**Champlain Hudson Power Express ("CHPE")
Environmental Management & Construction Plan
Notice of Major Change**

Project: Champlain Hudson Power Express

Segment: 12

Notice Number: 054

PERMIT DRAWING NO. N/A
 DRAWING NO. C-124

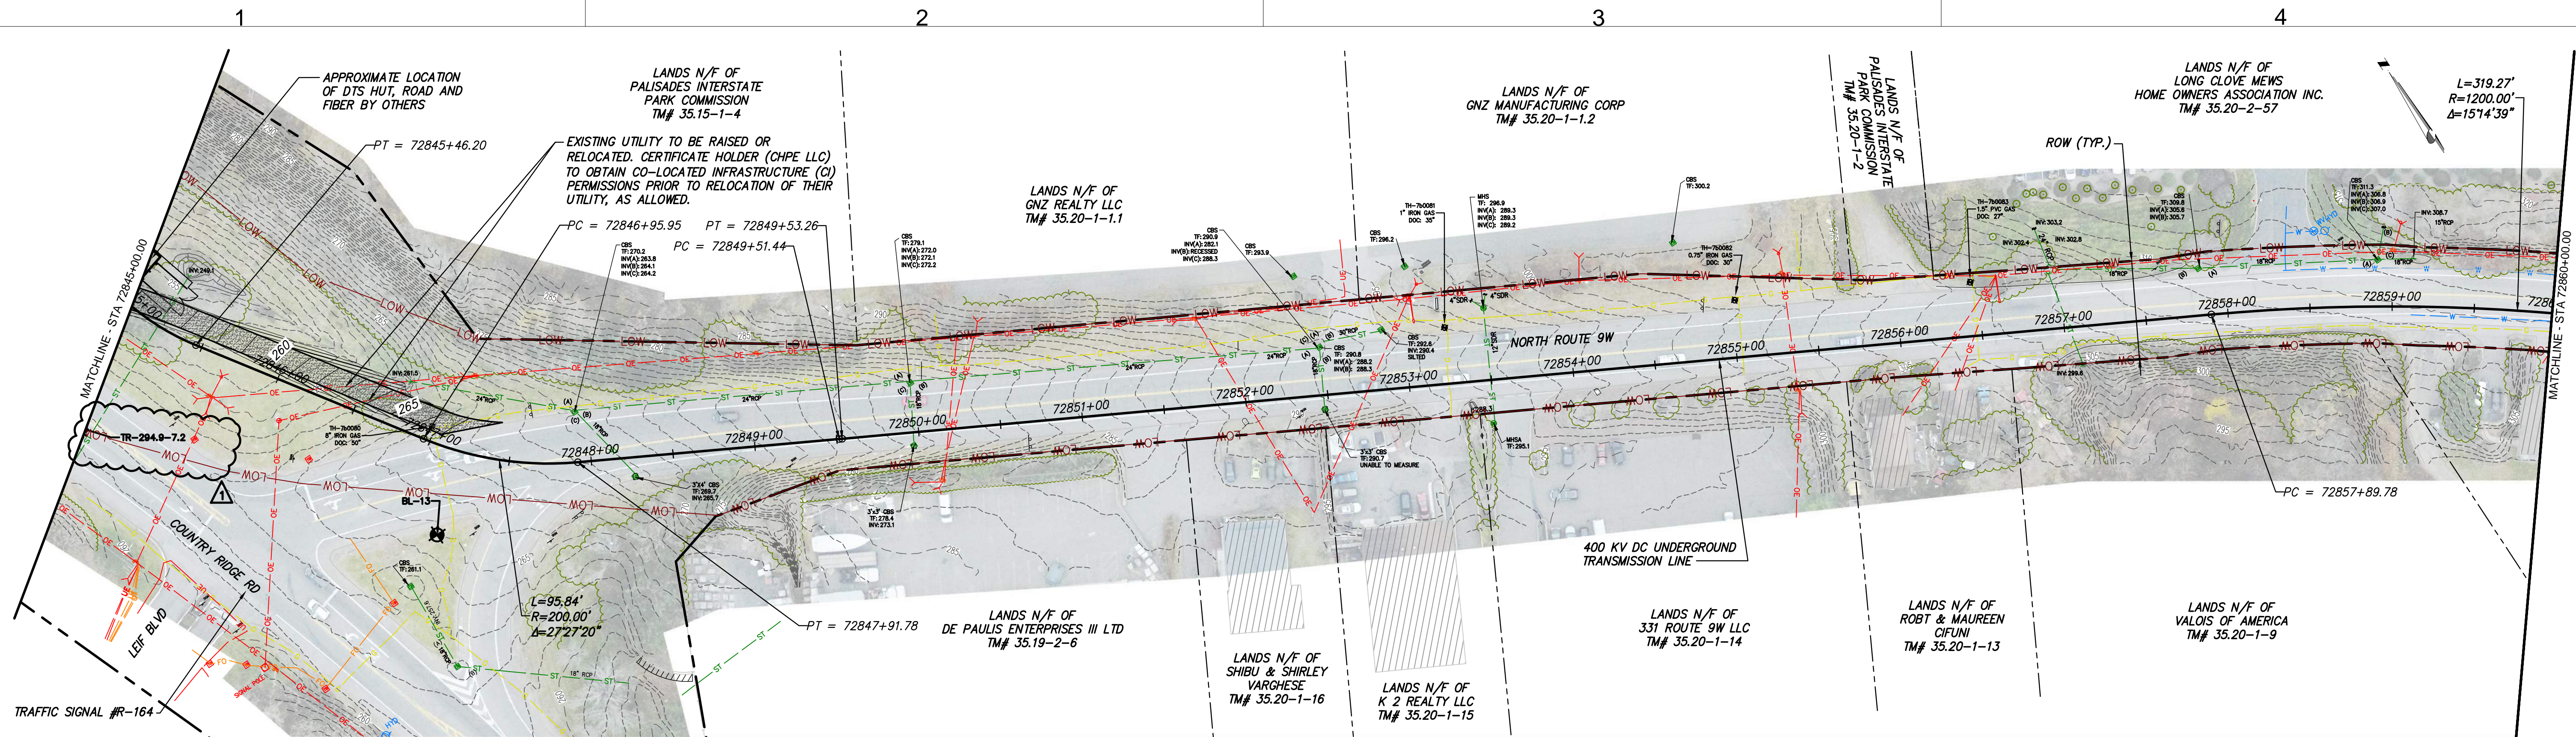
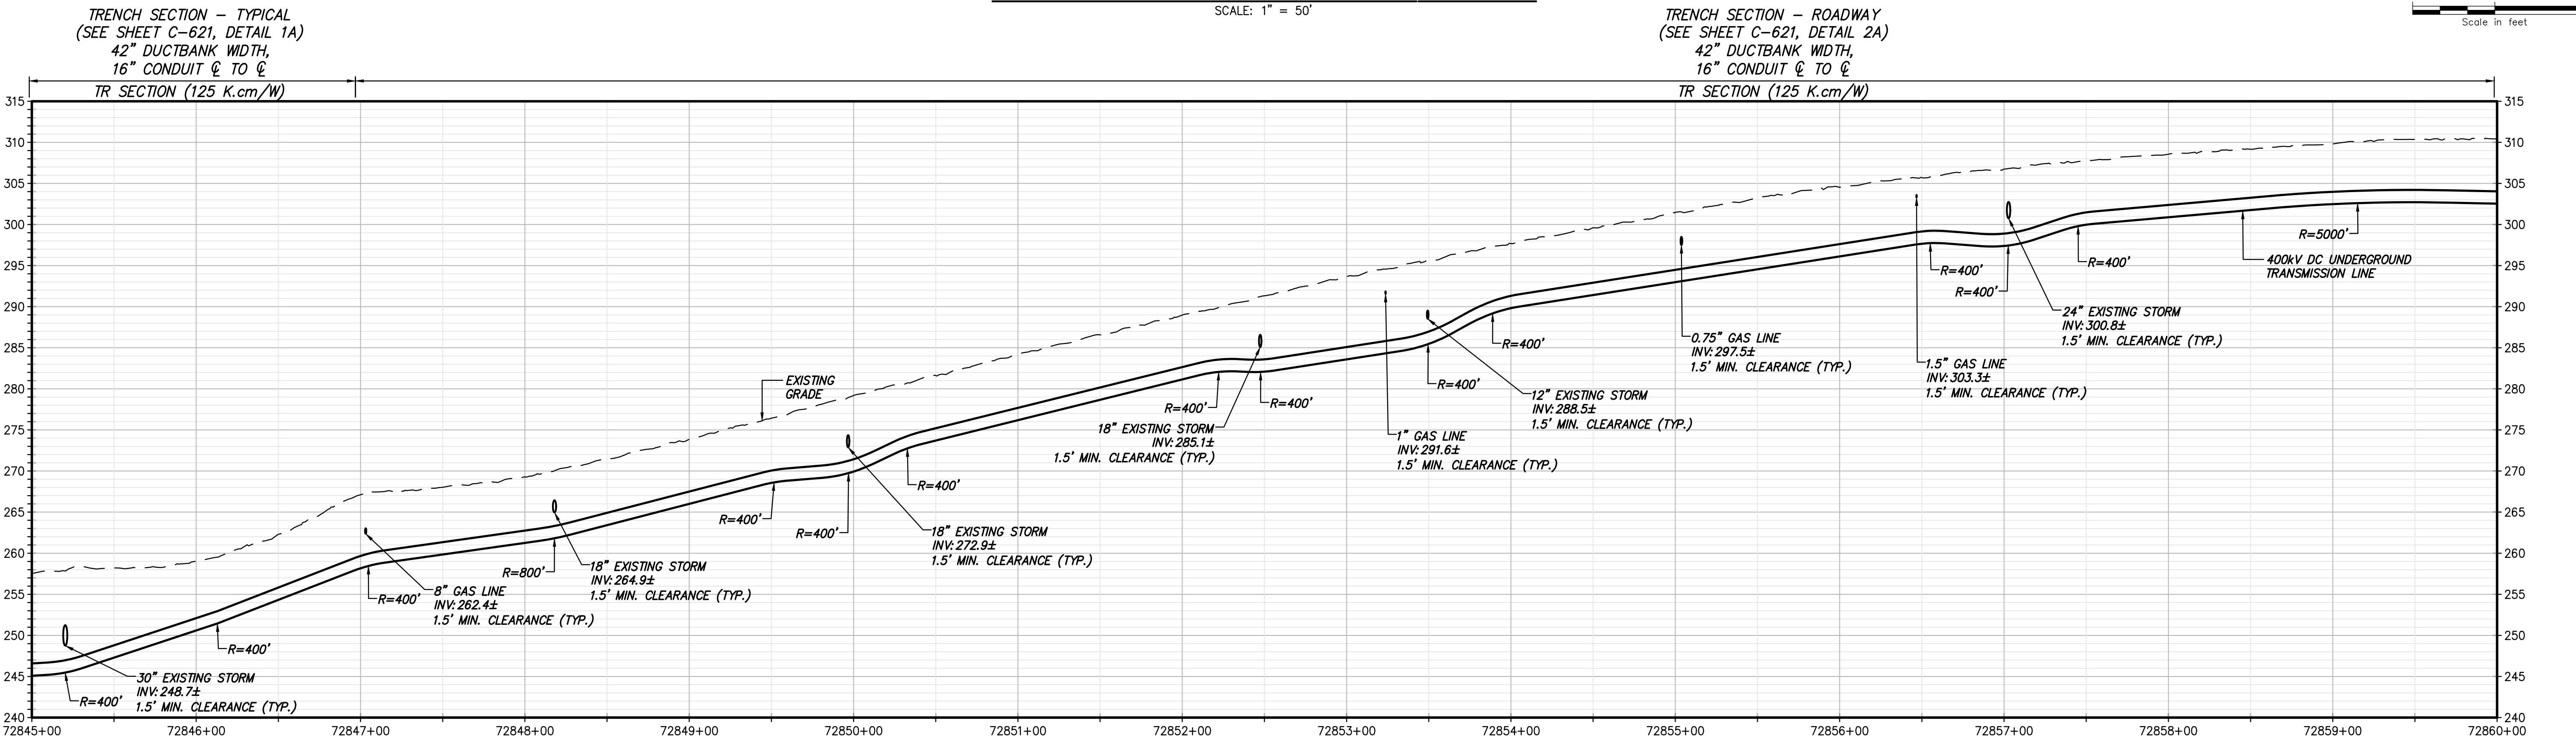
- Notes from Orange and Rockland (Gas & Electric) added to sheet G-004.
- Location of additional soil borings have been added (Shts. C-101, C-103, C-106, C-107, C-109, C-112, C-118, C-124, & C-125).
